21-COA-0084
1105 S. 1st St.

Old Louisville Architectural Review Committee
Public Hearing

Bradley Fister, Historic Preservation Specialist
June 15, 2022

7200 SERIES

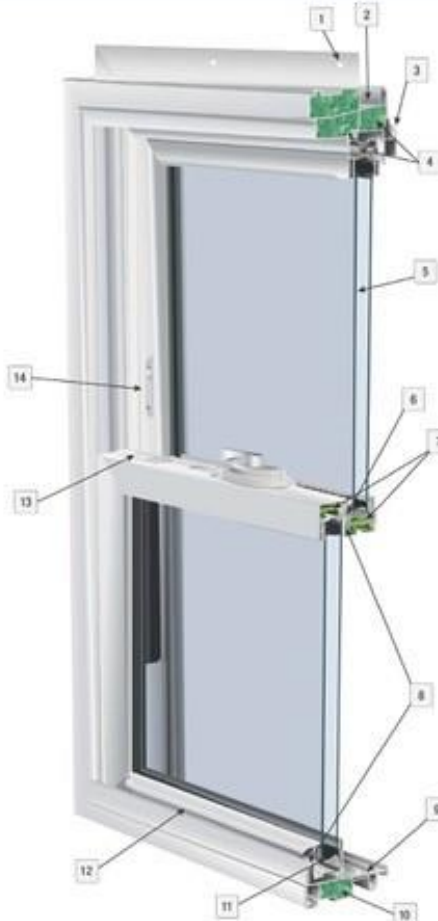
On the basis of the information furnished by the applicant, staff recommends a Certificate of Appropriateness be **denied** as the vinyl replacement windows do not meet the design guidelines.

1. The front facing replacement windows shall be replaced with a wood or clad wood window that fits the historic window openings and matches the original window configuration of two-over-two.
2. The 28 side and rear replacement windows shall be replaced with new vinyl windows that match the original window configuration of two-over-two.
3. The glass shall not be smoked, tinted, low-E, or reflective. Clear low-E glass is permissible.
4. The applicant shall not wrap the window trim or sills with vinyl or aluminum.
5. If the design or materials change, the applicant shall contact staff for review and approval.
